**Rix's Creek & Rix's Creek North Coal Mines  
Exploration and Overburden Emplacement Modification  
(DA 49/94 Mod 9 & MP 08\_0102 Mod 7)**

**Environmental Assessment Report**  
**Section 75W of the *Environmental Planning and Assessment Act 1979***

Figure 2 – Proposed exploration drilling location

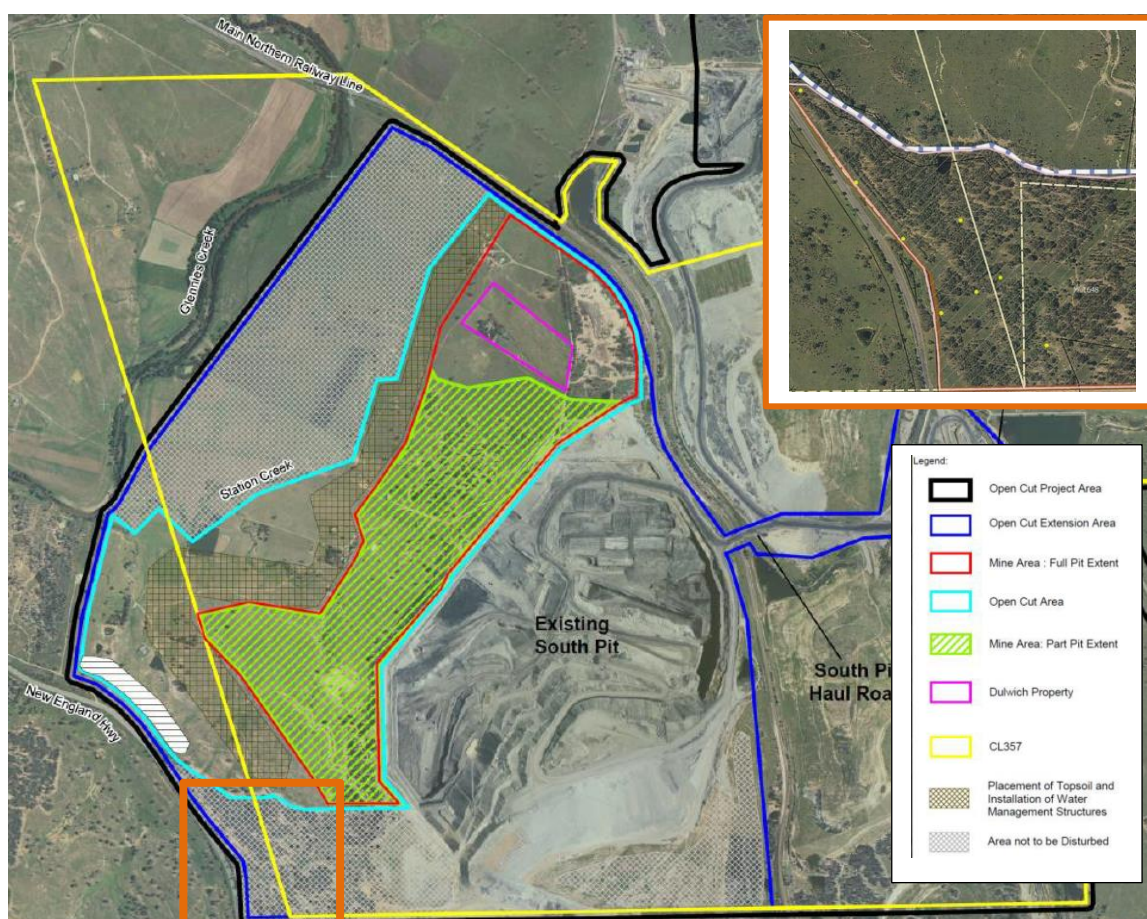
The **EPA** requested additional information regarding the location of exploration drilling in relation to the Environment Protection Licence (EPL) boundary, and the disposal of drilling muds, groundwater and core material.

OEH noted that the proposed borehole drilling would require clearance of <0.5 hectares (ha) of the endangered ecological community (EEC) *Central Hunter Grey Box-Ironbark Woodland in the New South Wales North Coast and Sydney Basin Bioregions*. OEH also noted that the ecological surveys undertaken in June 2017 could not have identified the presence of the threatened orchid *Diuris tricolor*, as it is only identifiable when it flowers in September and October. Consequently, OEH recommended that the proposed disturbance areas be surveyed for *Diuris tricolor* during its flowering season, prior to any works being undertaken.

As discussed in Section 4.2, OEH raised concern that the site inspection of each drill hole site was conducted in June and that the *Diuris tricolor* is only identifiable when it flowers in September and October. Consequently, OEH recommended that the proposed disturbance areas are surveyed for this orchid during the appropriate flowering period, prior to any works being undertaken. OEH recommended that, if any *Diuris tricolor* were identified during these surveys, they must be avoided or, if harmed, appropriately offset. The Department agrees with OEH's position and considers it imperative that the *Diuris tricolor* is appropriately avoided or offset (if required).

In its RTS, Bloomfield advised that drilling would occur wholly within the EPL boundary and that drilling mud would be retained onsite using sump tanks in accordance with the EPL. Bloomfield also advised that the sump tanks allow for groundwater make to be re-used in accordance with the EPL and core materials from boreholes would be retained on site for assessment. Following review of the RTS, the EPA raised no further questions on this matter.

In its RTS, Bloomfield advised that an ecologist had been engaged to undertake a *Diuris tricolor* survey during the peak flowering time in early October. Bloomfield committed to using the results of this survey to avoid disturbance to any of these plants. The proposed borehole locations would be in areas that predominantly consist of grassland which have been subject to previous clearing. The Department considers that with appropriate targeted surveys, impacts to *Diuris tricolor* can be avoided. A condition of approval has been recommended for Bloomfield to undertake a targeted survey in consultation with OEH prior to the

Bloomfield also agreed to rehabilitate the disturbed areas within 12 months of completing the exploration program, and replant any cleared trees greater than 2 m in height, at a ratio of 2:1. The Department has recommended conditions of approval to reflect this agreement. MP 08\_0102 already requires Bloomfield to prepare and implement a Rehabilitation Management Plan for the site. The Department notes that the necessary rehabilitation associated with exploration activities would be primarily managed under the relevant mining lease.
